## Different technical modifications and updatings on ruby 43-48

- Starting from serial number: 13000769 dated 21/02/13 (**ruby 43**, table 1202-10 R01)  
13001058 dated 20/03/13 (**ruby 48**, table 1202-10 R01)

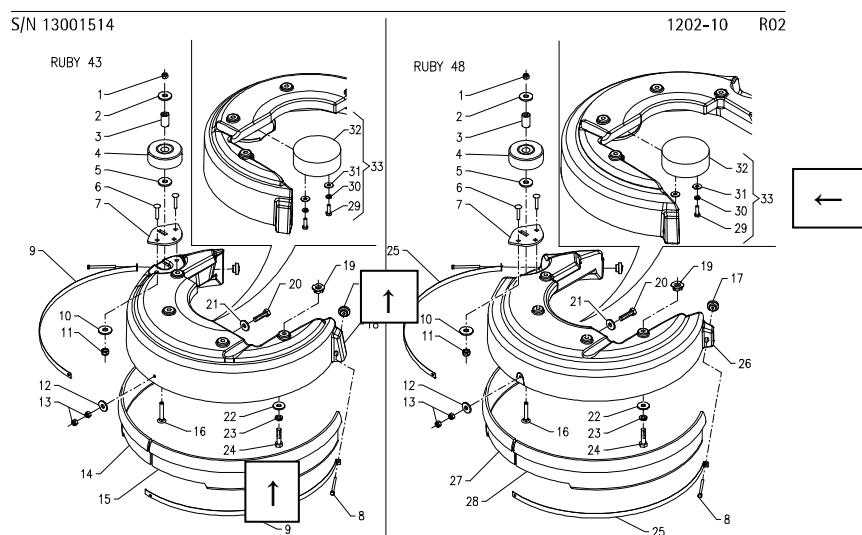
A counterweight (pos. 33 as assembly) has been added inside the cover to balance the machine in particular working conditions. The cover of ruby 43 (pos. 18) is not subject of changes, while the ruby 48 cover (pos. 26) has undergone some modifications in order to permit the weight insertion, therefore the part number changes, however both are interchangeable with the two previous covers.

The screw M6x45 (60110625) has been replaced with a shorter one, M6x40 (60110629). In the ruby 48 the modification is present since the beginning of the production.

We have furthermore corrected pos. 25 in the drawing (before we indicated pos. 9).

→ Starting from serial number: 13001004 dated 13/03/13 – table 1205-10 R00

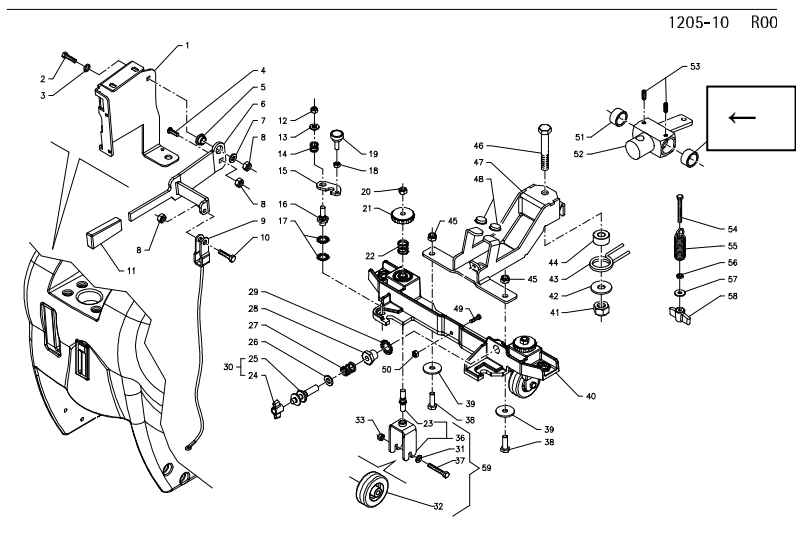
We have verified that in some cases the articulated joint with the square end did not permit a perfect oscillation of the arm. We have modified the joint (pos. 52) and the lower profile of the squeegee arm (pos. 47) to improve its oscillation in any working position. The new parts are interchangeable with the previous ones.

→ Starting from serial number: 13004496 dated 21/11/13 (**ruby 43** – table 1209-10 R00)  
13004518 dated 20/11/13 (**ruby 48** – table 1209-10 R00)

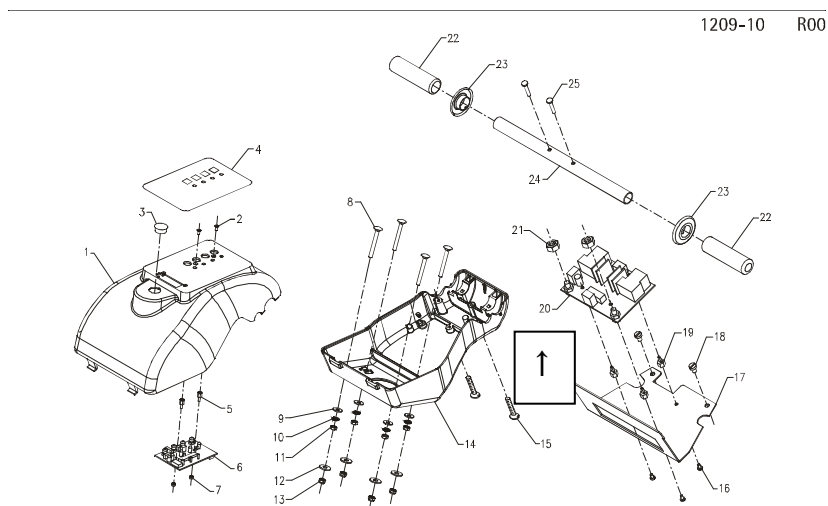
The check card relay 49705040 with brush motor relay of 40A has the condenser of 470nF on the 40A-relay. Because of some breakdowns we have replaced the 470nF condenser with a 1500nF one. The check cards are interchangeable with the previous ones.

Some corrections and updates on table 1210-10 R00:

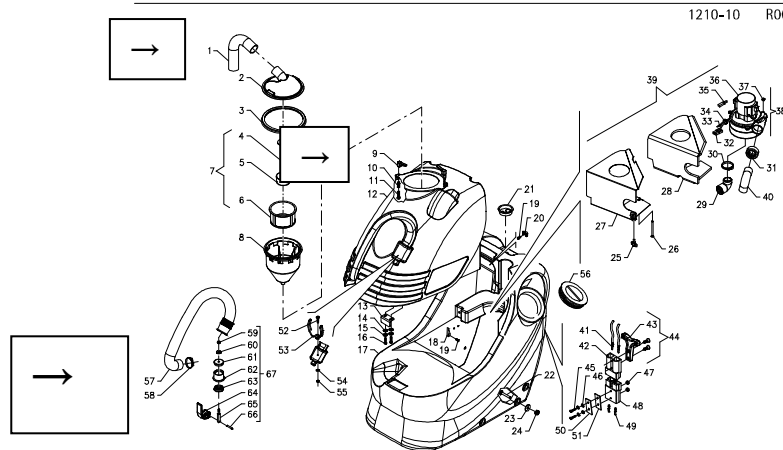
pos. 1 the correct length of the hose 47610130 is: 720mm

pos. 10 the quantity of the springs 47210080 is two

We have furthermore added the group of the exhaust hose and its plug.

Correction on table 1210-20 R00:

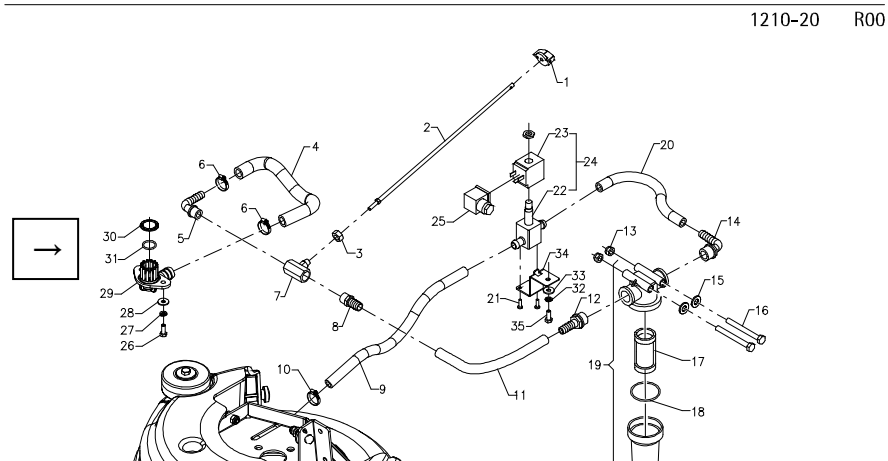
Positions 30 and 31 in the drawing have been corrected, inverting them.

Some corrections and updates on table 1213-10 R00:

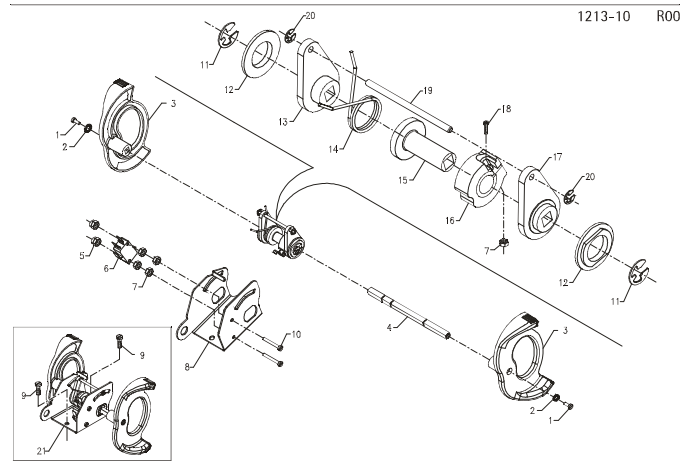
pos. 5 the correct part number of the nut is: 60220301

pos. 22 of the drive control assembly has been replaced with pos. 21 as shown in the drawing.
